ERRATA

July 2015

Recently, we were made aware of some technical revisions that need to be applied to the *Roadside Design Guide*, 4th Edition.

Errata to Roadside Design Gu	<i>lide,</i> 4 th Edition
------------------------------	--------------------------------------

U.S. Customary Units

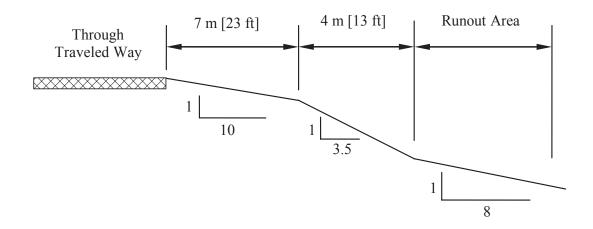
Page	Existing Text				Corrected Text			
3-3			5. Customary un le Design Speed		The attached replacement page shows the correct backslope values as follows:			
	Design AD	г	Backslope		Design ADT		Backslope	
	Design ne	1V:3H	1V:5H to 1V:4H	1V:6H or Flatter	Design AD	1V:3H	1V:5H to 1V:4H	1V:6H or Flatter
	Under 750		7–10	7–10	Under 750	7–10	7–10	7–10
	750-1500	12–14	12–14	12–14	750-1500	10-12	10-12	10-12
	1500-6000	14-16	14–16	14–16	1500-6000	12–14	12–14	12–14
	Over 6000	16–18	16-18	16–18	Over 6000	14–16	14–16	14–16
3-21	Example 3-D does not have "Discussion" text to follow after the figure.				Add the following text: "Discussion —Since the critical foreslope is with the suggested clear-zone distance of 9 to 10.5 m [30 to 34 ft], it should be flattened if practical or considered for shielding. However, if this is an isolated obstacle and the roadway has no significant crash history, it may be appropriate to do little more than delineate the drop-off in lieu foreslope flattening or shielding."			of 9 to 10.5 m if practical or ; if this is an has no e appropriate to

EXAMPLE 3-K

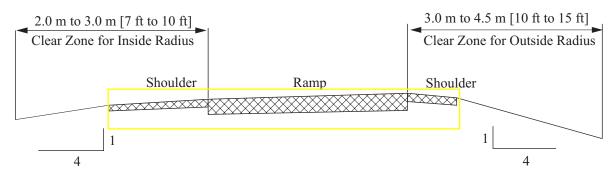
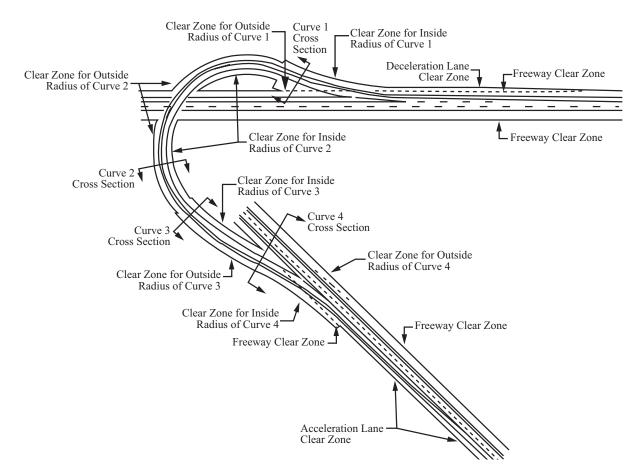
3-26	Example 3-K, Curve 2—The cross sections in the figure need to be banked the opposite direction in order to correspond to the plan view as shown on page 3-27.		Substitut revised fi		ple 3-K with the	e attached		
		Also, the dimension "[11 to 15 ft]" should be changed to "[10 to 15 ft]."						
3-28	sections i opposite	in the fig directio	urves 2 and 3—7 gure need to be n in order to co wn on page 3-29	banked the rrespond to the	Substitut revised fi		ple 3-L with the	e attached
		ion "[10.5 to 15 ed to "[10 to 15 :	ft]" for Curve 2 ft]."					
3-29	Example 3-L, Curve 4—The dimension "[14 to 16.8 ft]" for Curve 4 should be changed to "[14 to 16 ft]."							e attached
5-12	For NU-GUARD by Nucor Marion in Table 5-3, the Test Level is listed as "3" and the FHWA Acceptance Letter is listed as "B-162."		, Change the Test Level for NU-GUARD to " <u>and 4</u> " and the FHWA Acceptance Letter to "B-162 <u>and B-162B</u> ."

Figure 5-35(a). Example Laydown Curb for Use Offset from Guardrail

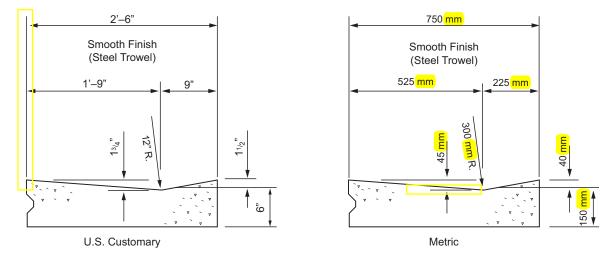
5-42	The second sentence of the last paragraph reads "The design incorporates 2.74-m [9-ft] long posts"			ls Change the text to read "The design incorporates 2.74-m [9-ft] long <u>steel</u> posts				
5-43	missing a metric di	t dimens rawing h	the U.S. custom sion line on the f nas an extra line o the top of the p	far left side; the connecting a	Substitut revised fi		e 5-35(a) with th	ne attached

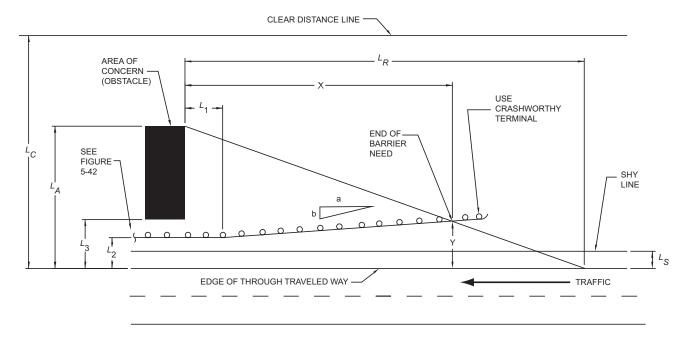
Page	Existing Text	Corrected Text		
5-49	Figure 5-39 refers to Figure 5-22.	The correct cross reference is to Figure 5-42.		
5-58	Figure 5-47 has partial text missing.	Substitute Figure 5-47 with the attached revised figure.		
6-2	Figure 6-1 shows incorrect metric and U.S. measurements for median widths.	Substitute Figure 6-1 with the attached revised figure.		
6-7	Figure 6-4 shows incorrect image of Brifen Wire Rope Safety Fence.	Substitute Figure 6-4 with the attached revised figure.		
8-9	Table 8-2 requires several changes under Height Terminals, Flared Terminals, and Tangent Terminals.	Substitute Table 8-2 with the attached revised table.		
8-19	The first sentence of Section 8.3.7 reads "This section describes end terminals and their design criteria for two box-beam guardrail systems."	Change this sentence to read "This section describes the terminals for the box-beam guardrail system discussed in Chapter 5."

Figure 10-4. Landscape and Rigid Object Placement for Buffer Strip Widths ≤1.2 m [4 ft]

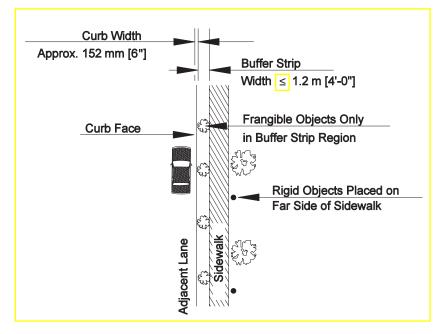
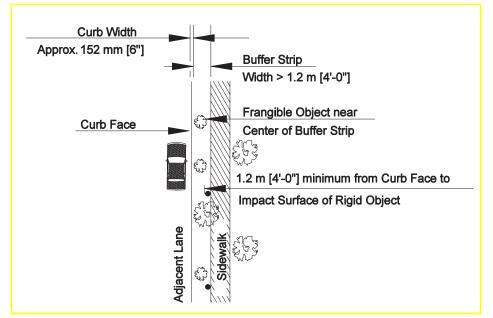
8-48 & 8-49	In Table 8-12, Sand Filled Barrels is placed in the wrong section.	Substitute Table 8-12 with the attached revised table.		
10-10	The illustrations for Figures 10-4 and 10-5 need to be transposed.	Substitute the attached page with the revised illustrations in the correct order.		
	Also, the width of the Narrow Buffer Strip should be "≤1.2 m [4′-0″].			
11-7	Figure 11-5 shows incorrect measurement of taper for LS.	Substitute Figure 11-5 with the attached revised figure.
